RESPONSE TO REQUEST FOR ADDITIONAL INFORMATION

APR1400 Design Certification

Docket No. 52-046

RAI No.: 517-8670
SRP Section: 19.03 – Beyond Design Basis External Event
Application Section: 19.3
Date of RAI Issue: 08/19/2016

Figure B-1 Spent Fuel Pool Monitoring Water Level

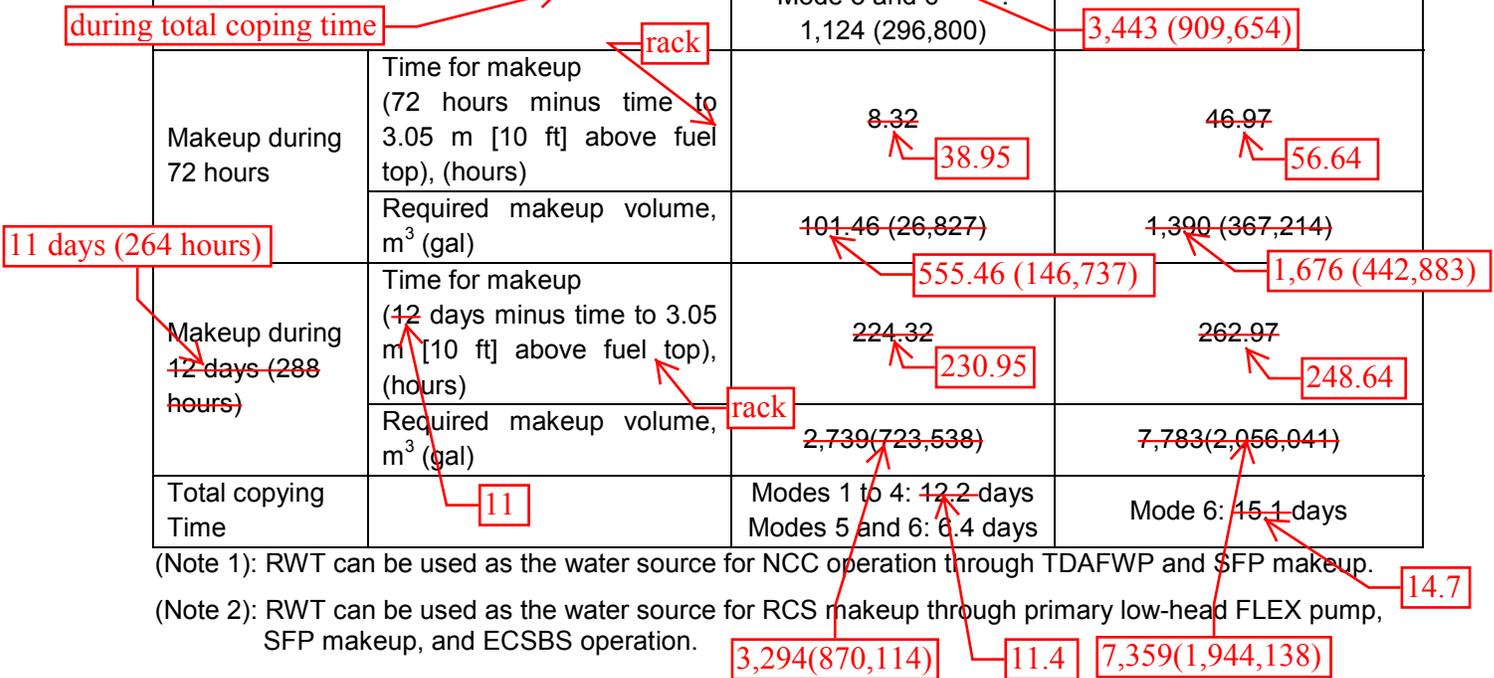
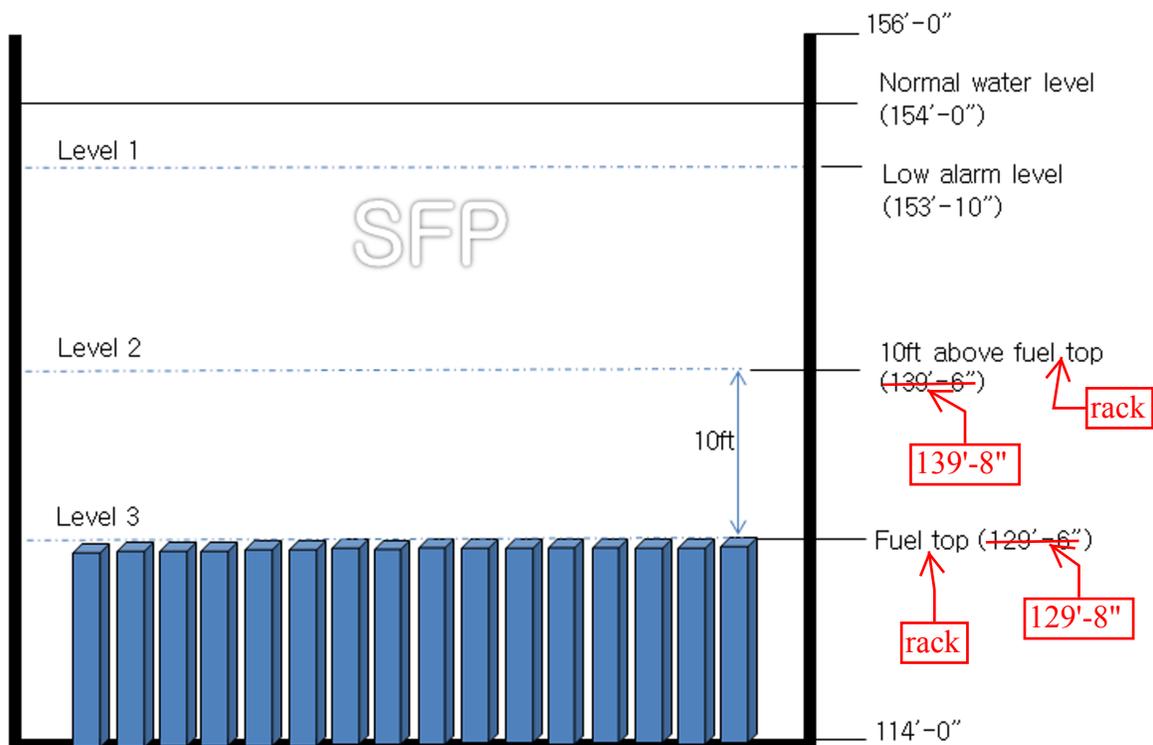
NEI 12-06, Section 3.2, "Performance Attributes," (ML12242A378) indicates that "installed equipment that is designed to be robust with respect to design basis external events is assumed to be fully available." The applicant is requested to justify/clarify the robustness of pipes that interact with the SFP that are located below the initial SFP water level assumption used in the

calculation (i.e., 154'), or to revise the assumption of the initial SFP water level and re-do the SFP analysis for BDBEEs, and revise the Technical Report and DCD accordingly.

The elevations of all pipes that penetrate the SFP are described in the response to RAI 77-7991, Question 09.01.03-1. The elevation of the SFP cleanup suction nozzle, which is located at the lowest elevation among the non-Seismic Category I pipes (Seismic Category II), is EL. 149'. Therefore, the EL. 149' is assumed as the initial water level of the SFP during BDBEEs to conservatively calculate SFP boil-off time.

- Initial SFP water level is assumed at ~~normal water level~~.
- SFP inventory makeup starts when the water level reaches Level 2 defined in NEI 12-02 and shown in Figure B-1.

- For mode 6 with maximum SFP heat loads due to a full core offload, the time to boil is reduced to ~~4.3~~ hours after an ELAP. As a result of boiling, SFP level reaches 3.05 m (10 ft) of water above the irradiated fuel assemblies in approximately ~~25.03~~ hours after an ELAP. Within ~~25.03~~ hours, Phase 2 actions should be initiated to provide makeup water to the SFP from the RWI using the portable pump. 2.0 15.36 15.36
- In a postulated ELAP, the required SFP makeup flow rate to match the boiloff for modes 1 through 6 with core not offloaded is ~~203.5 L/m (53.76 gpm)~~, and the SFP makeup flow rate for mode 6 with the full core offload is ~~493.28 L/min (130.31 gpm)~~. 237.7 L/min (62.79 gpm) 493.2 L/min (130.3 gpm)
